SUBJECT: Tinley Park Helistop
Tinley Park, Illinois
Cook County
Illinois Project Number: TF8-5050
Contract No. TI001
Item No. 04A, April 28, 2023, Letting
Addendum A

NOTICE TO PROSPECTIVE BIDDERS

Reason for Addendum:

HELISTOP AIRCRAFT PAVEMENT IMPROVEMENTS

DRAWING TITLE
INDEX OF SHEETS, SUMMARY OF QUANTITIES, AND GENERAL NOTES

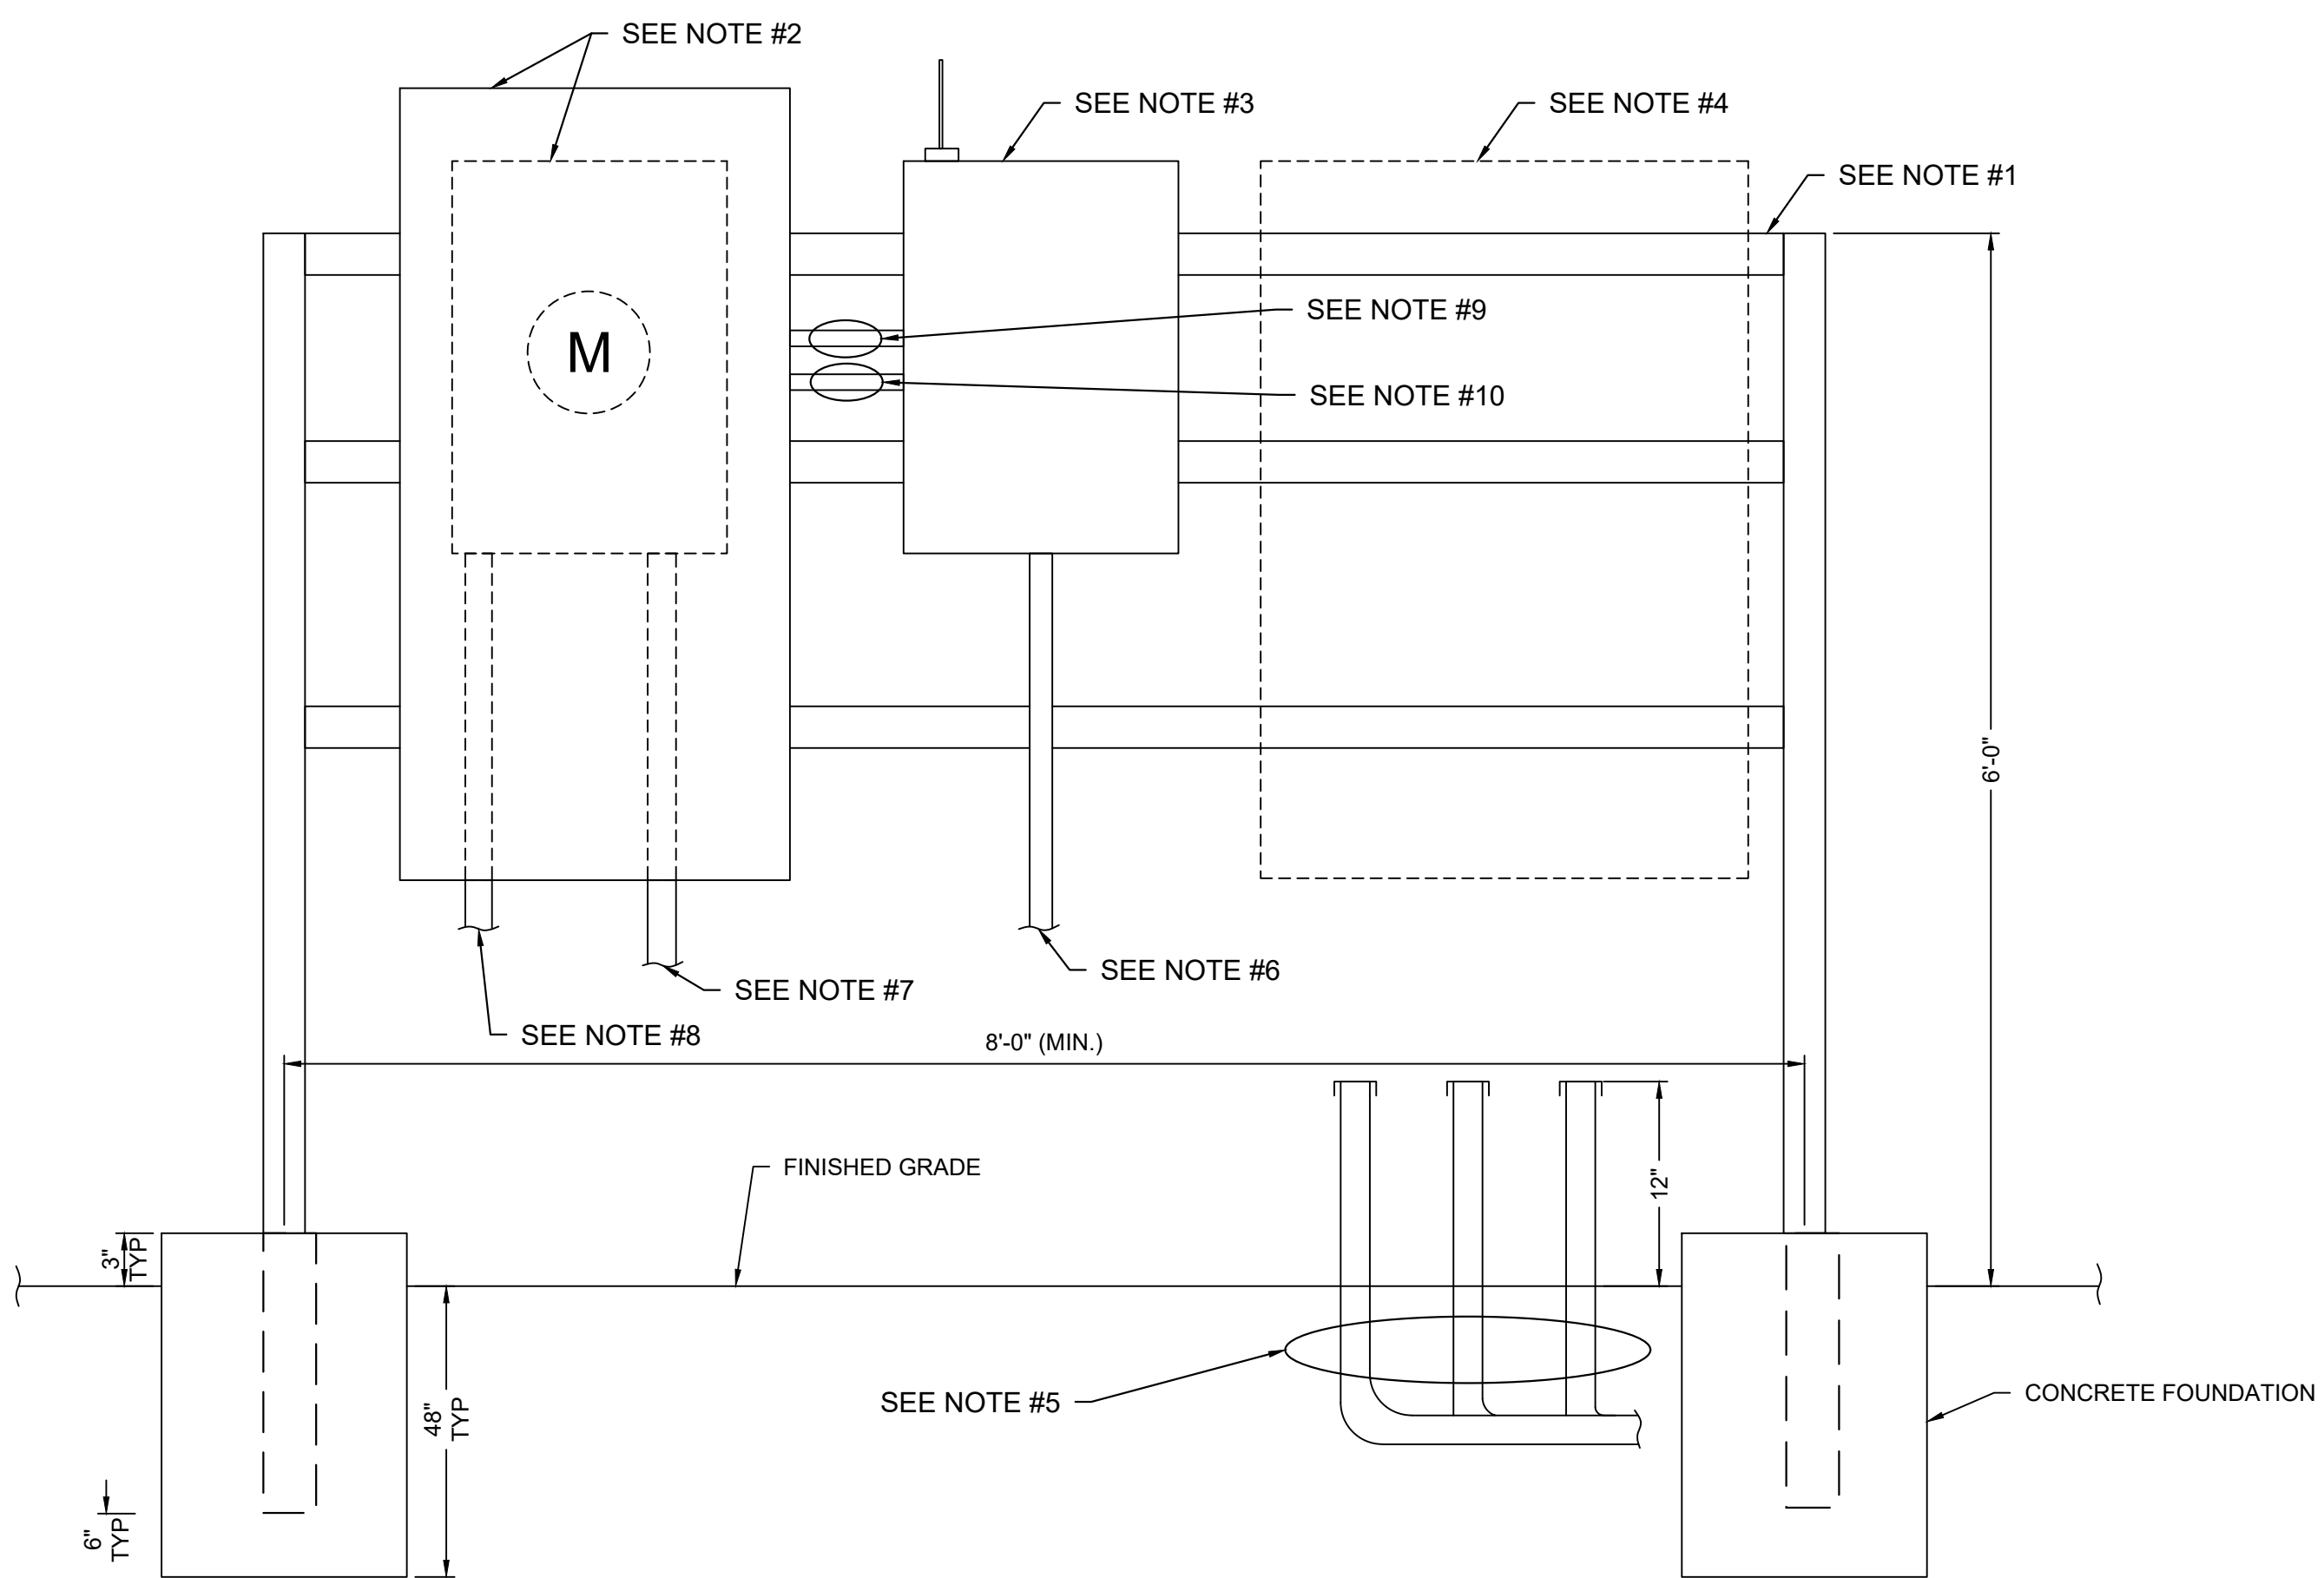
- 1) Revise in-pavement light fixture from L-852H to L-852T(L).
- 2) Clarify the callout and location for Concrete Encased 4-Way, 2" PVC Duct.

- 1) Drawing C1.0 Sheet Index and Summary of Quantities
- 2) Drawing C13.0 Proposed Electrical Site Plan
- 3) Drawing C13.1 Proposed Electrical Notes
- 4) Drawing C13.2 Electrical Details
